Service Information

Model Nakamichi 550
Serial No. from 3601871

Subject MHX Motor Ass'y and MHX Governor P.C.B. Ass'y No. NR-0007 (1/6)
(B) Modification Procedures for Previous Models Date 9 August 1976

Fig. 1

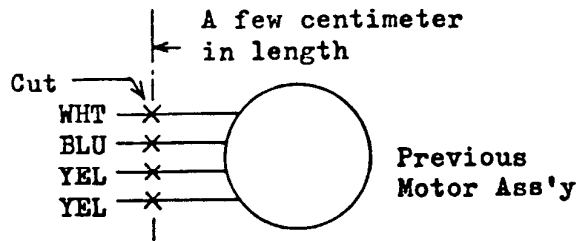
- (1) Remove the Motor Ass'y (NE) (Motor, Pulley and Bracket) and replace with MHX Motor Ass'y (Motor, Pulley and Bracket).
- (2) Cut the previous type motor-signal-wires (BLU, WHT, YEL, YEL) referring to Fig. 1. Then connect to the new motor referring to Fig. 2.
- (3) Cover with tube for isolation at the connecting point of two wires.
- (4) After replacement of motor ass'y, adjust the pulley position of the new motor as shown in Fig. 3 then check the position of driving belt to insure the following:
 - (a) Set a driving belt through Flywheel, Idler Pulley, Belt Guide and Motor Pulley.
 - (b) Turn the motor back and forth by hand and check to insure whether the drive belt is travelling along the correct position i.e. the center part of the idler pulley without contacting the belt guide.
 - (c) Fasten the screw of the motor pulley and then apply a drip of lock tight paint.

Fig. 4

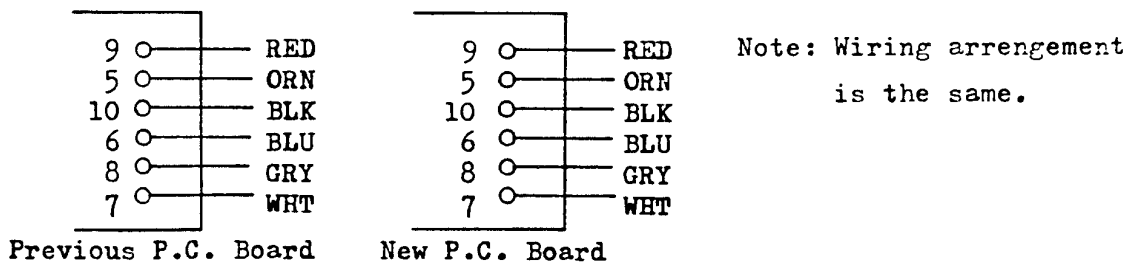
- (1) Remove previous type D-D, D-Fast Converter & Motor Governor P.C.B. Ass'y, and replace with new D-D Converter & MHX Governor P.C.B. Ass'y.
- (2) Unsolder signal wires from the previous type governor and resolder to the new one.

Fig. 5

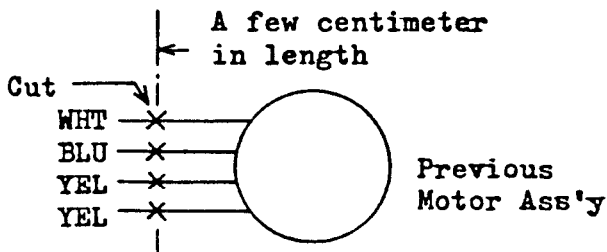
Refer to Fig.5 and 6.

- (1) Remove the Motor Ass'y (JA) (Motor, Pulley and Bracket) and replace with MHX Motor Ass'y (Motor, Pulley and Bracket).
- (2) Cut the previous type motor-signal-wires (WHT,BLU,BRN), and connect the disconnected signal-wires (WHT and BLU) with new motor-signal-wires (RED and BLU).
Cut the 4P connector ass'y-signal-wires (BRN,BLK,GRN,ORN), and connect the disconnected signal-wires (BLK,GRN and ORN) with new 5P connector ass'y-signal-wires (BLK,GRN and ORN).
Connect motor-signal-wires (YEL and YEL) with 5P connector ass'y-signal-wires (YEL and YEL).
- (3) Cover with tube for isolation at the connection point of two wires.
- (4) After replacement of motor ass'y, adjust the pulley position of the new motor as shown in Fig. 7, then check the position of driving belt to insure the following:
 - (a) Set a driving belt through Flywheel, Idler Pulley, Belt Guide and Motor Pulley.

Fig. 7

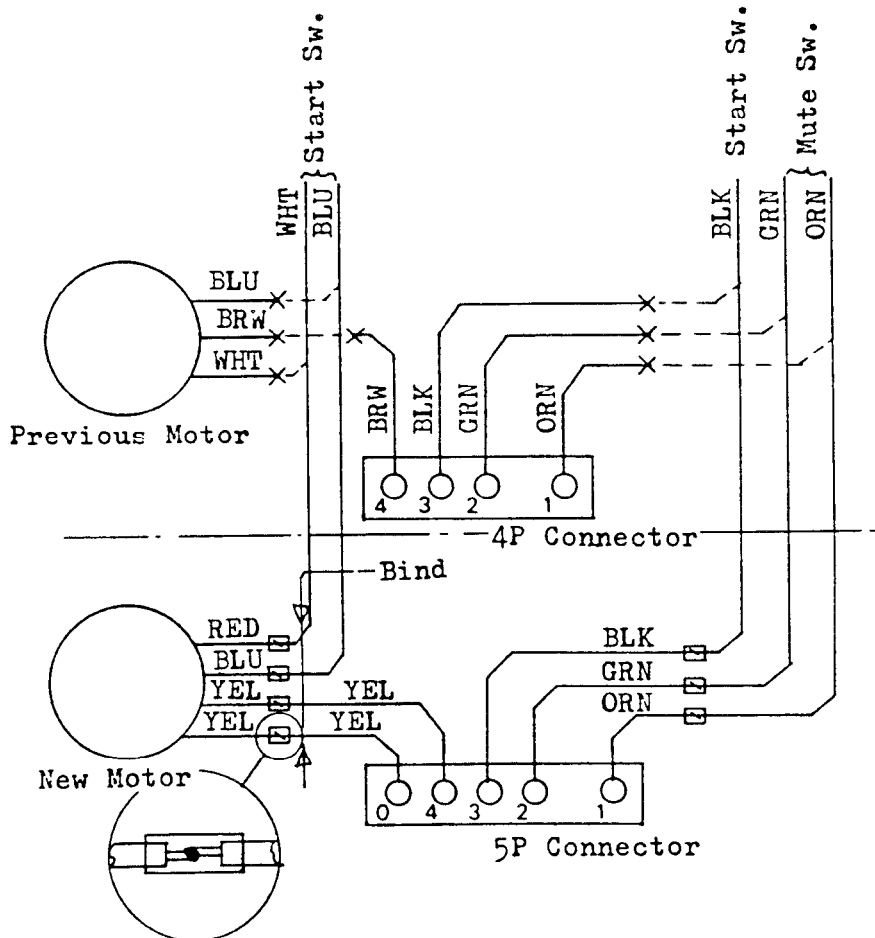
- (b) Turn the motor back and forth by hand and check to insure whether the drive belt is travelling along the correct position i.e. the center part of the idler pulley is free from contact with belt guide.
- (c) Tighten the motor pulley screw then apply a drop of lock tight paint to that screw.

Fig. 8

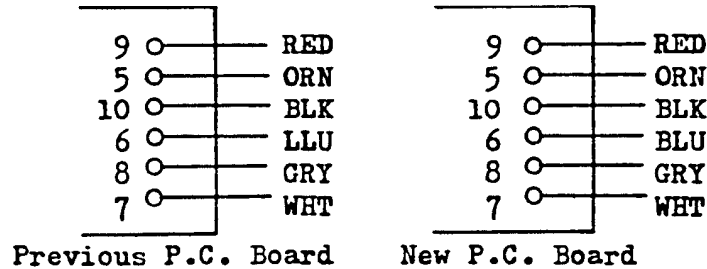
- (1) Remove previous type D-D Converter & Motor Governor P.C.B. Ass'y, and replace with new D-D Converter & MHX Governor P.C.B. Ass'y.
- (2) Unsolder signal wires from the previous type governor and resolder to the new one.
